Project Name: Proposed Riverside South Elementary School, 836 Solarium Avenue, Ottawa, Ontario

Subject: Geotechnical Response to First Round of Comments from City of Ottawa

City of Ottawa File No. D07-12-22-0145

Figure 1 – Soil Plasticity Chart

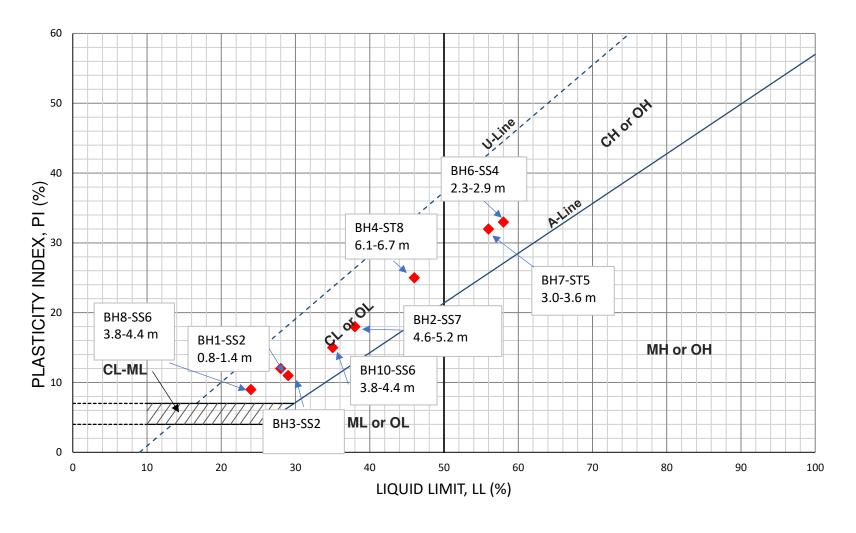
City of Ottawa Comment 1.26: Please append the results of the Atterberg limit laboratory testing.

EXP Response to Comment 1.26: The Atterberg limit test results (liquid limit and plastic limit) and the determination of the plasticity index values of the clayey silt and clay soils are provided in Table IV (page: 9) of the final geotechnical report dated September 21,2022 and shown below. The soil plasticity chart is shown in the attached Figure 1.
